TOWN OF CARMEL
ENVIRONMENTAL CONSERVATION BOARD

ENVIRONMENTAL CONSERVATION BOARD AGENDA

**Response to ECB comments Duran, 928 Peekskill Hollow Road, Sports Court Construction
ECB meeting May 2020**

RE: Wetland Mitigation Plan, Diego Duran
928 Peekskill Hollow Road, Carmel and Putnam Valley, NY

OWNER:	LORENA M. & DIEGO DURAN 928 PEEKSKILL HOLLOW ROAD CARMEL (T)	SCALE: 1" = 30'	LATEST REVISION:
EXISTING CONDITION PLAN		DATED: AUGUST 20, 2019	SHEET NO. S-1
		TAX LOT: 53-1-19

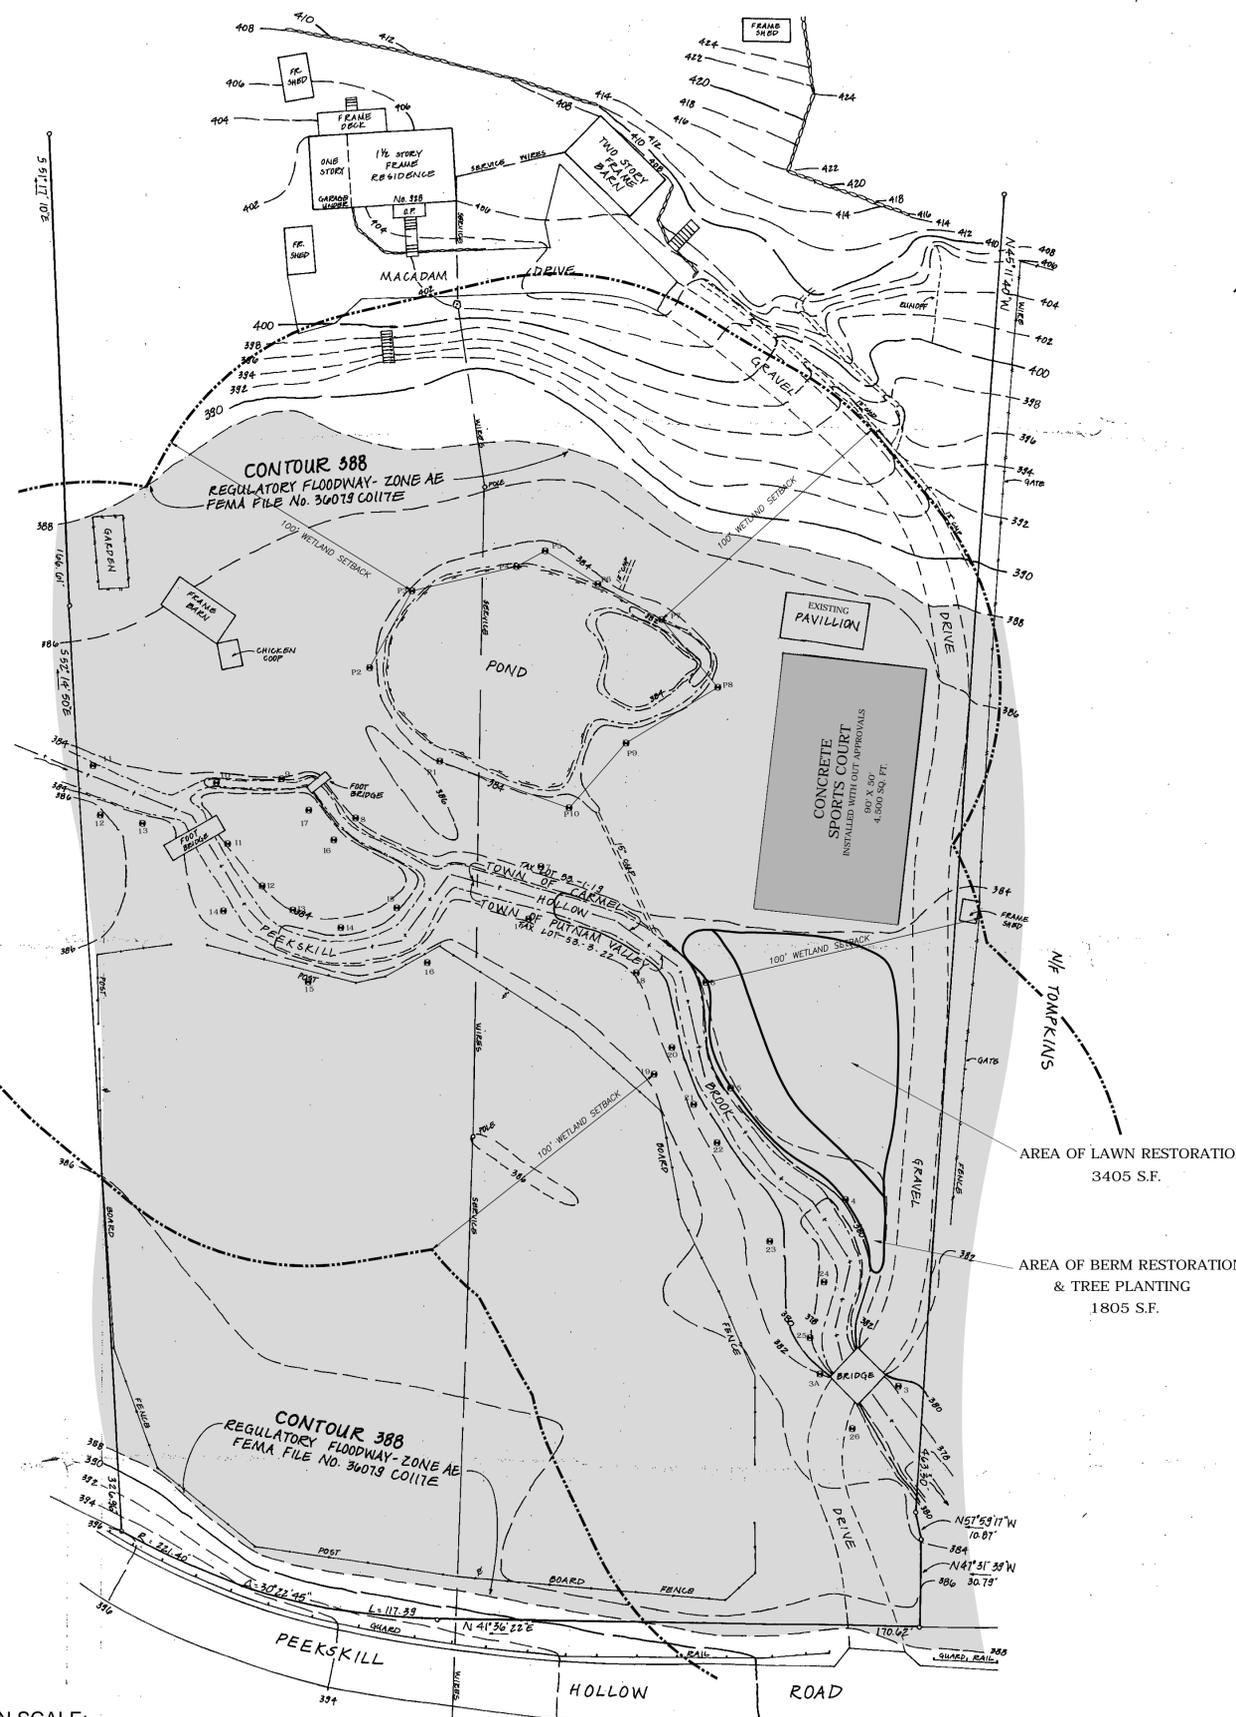
The only comment was to provide a mitigation plan for the disturbance within the wetland or wetland buffer.

The attached mitigation plan was prepared by Ted Kozlowski. The report has been converted to notes and placed on the plans.

WETLANDS MITIGATION PLAN

1. Inspection: The area between the brook and the concrete pad was inspected to formulate a mitigation plan. The berm along the east side of Peekskill Hollow Brook is existing and not well vegetated. The area between the berm and the pad is lawn.
2. The berm is to be scarified and extended along and out from the brook in the area as shown on this plan so it gradually levels off. Upon completion of the scarification it should be seeded with ERNST Raparian Buffer seed mix #178 at a rate of 20 lbs. per acre. The seed should be lightly covered with salt hay.
3. A tree planting zone must be created between the berm buffer and pad by planting a mix of 5 river birch trees (6-10', B&B) and 6 bald cypress (6-10') in a staggered pattern at least 15 feet apart. Trees need to be well watered in and mulched with 2-3" of compost mulch. The plantings will serve to protect the berm and shade the brook.
